ITEM 9. DEVELOPMENT APPLICATION: 41 BRIDGE ROAD GLEBE

FILE NO: D/2009/1723

Summary: The application proposes a fitout and change of use from a furniture workshop and showroom to a publishing business employing approximately 100 staff. The proposed hours of operation are: 8am to 5.30pm, Monday to Friday. The proposal includes: the extension of the existing mezzanine (additional 373m²); creation of a second mezzanine (180m²); and minor external alterations including two new roller garage doors to the rear.

Figure 2: Amended plans demonstrating 2.4m between floor and under side of trusses on mezzanine

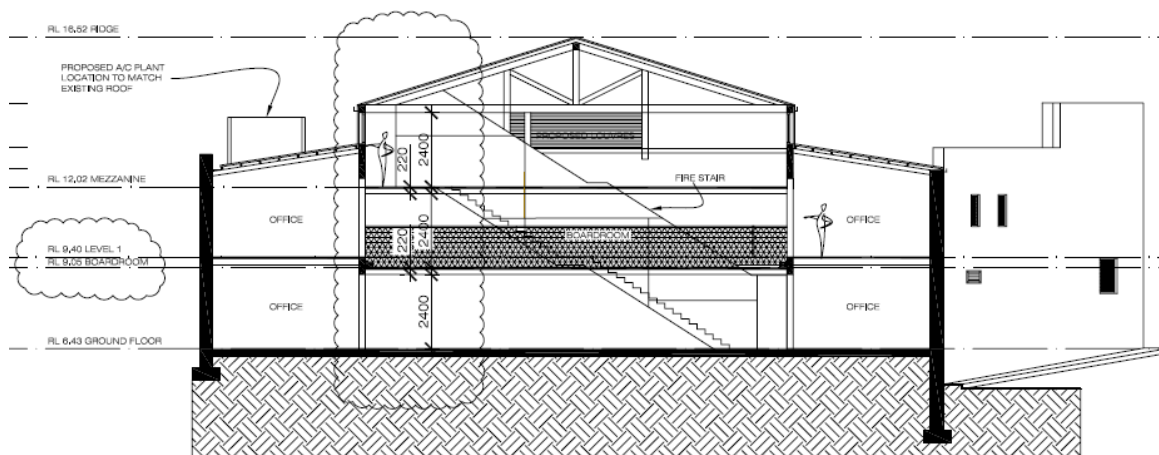
- (2) The second mezzanine has not been approved and does not form part of this deferred commencement consent.
- (3) The proposed garage door to the right hand side of the Bayview Street elevation has not been approved and does not form part of this deferred commencement consent.

30. The proposed second mezzanine is not supported as the original application provided insufficient height (1.67m) between the trusses and the floor of the second mezzanine. To achieve compliance with the BCA's minimum head height of 2.4m, the applicant has submitted amended plans with a 2.4m height between the floor of the mezzanine and the lowest side of the roof trusses. However, in order to achieve this height, the floor to ceiling height of the first floor has been reduced to 2.4m and the thickness of the floor has been reduced to 220mm. This results in reduced amenity within the office on both the first floor and proposed mezzanine. Further, it does not allow sufficient space between the ceiling and floor for the provision building services such as telecommunications, electrical, water, sewerage and air conditioning facilities.

- (b) delete the proposed second mezzanine from the proposed plans; and
 - (c) delete the proposed garage to the right hand side of the Bayview Street elevation.

Figure 4: Proposed Bayview Street Elevation

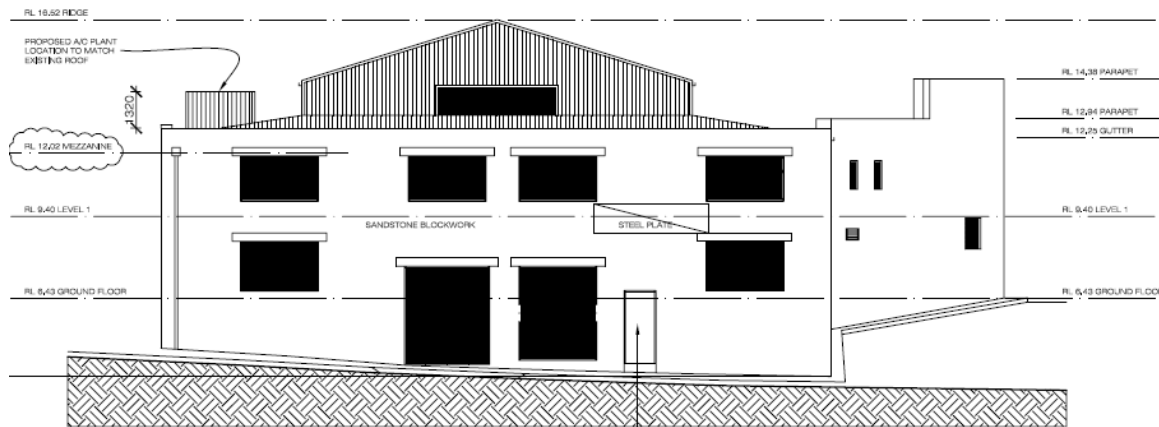
Amended plans must demonstrate the removal of this proposed garage door and associated vehicle cross-over. The internal configuration can be amended so as to include up to three off street car parking spaces. One car courier parking space and a minimum of 10 bicycle parking spaces must be accommodated.

32. The application proposes the provision of three car parking spaces on site, including one disabled car parking space and 10 bicycle parking spaces. Further, it is recommended as a condition of consent that one of the spaces be a dedicated courier space to accommodate the servicing requirements of the business. Two new garage doors are proposed for the site. One is proposed to replace the existing roller door, with the second requiring the loss of one existing on street car parking space. As discussed below, the second roller door is not recommended for approval.
